<b>Subject:</b>  NOISE FROM FRONT DOOR CHECKER AREA	<b>Bulletin No:</b> 09-012/13
	<b>Last Issued:</b> 04/29/2013

2013-2014 CX-5

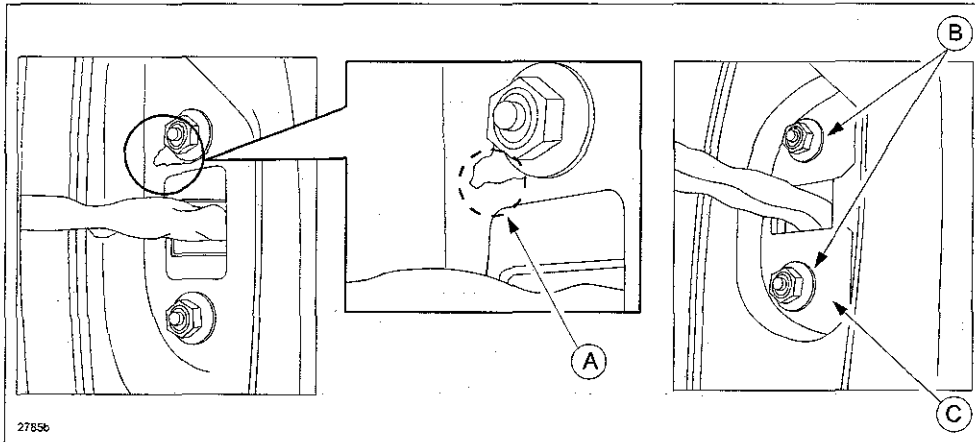
Some vehicles may experience noise from the front door checker installation location (A) whenever the door is opened. When the door is fully opened, the door checker may become over-stroked and cause a crack at the spot welding area around the door checker.

- a. Apply approx. 0.3 ml grease per side (using either molybdenum grease or lithium grease) on the welding point (A) (cracked area).
- b. Install plate (C) (checker reinforcement) on the body panel.  
**Tightening Torque (B): 71-106 in·lbf {8-12 N·m, 82-122 kgf·cm}**
- c. Repeat the repair on opposite side front door.

- a. Remove all corrosion found on the body panel.
  - b. Apply primer to the repaired surface.
  - c. Apply touch up paint to the repaired surface.
  - d. Install plate (C) (checker reinforcement) on the body panel.  
**Tightening Torque (B): 71-106 in·lbf {8-12 N·m, 82-122 kgf·cm}**
  - e. Repeat the repair on opposite side front door.
3. Verify repair.
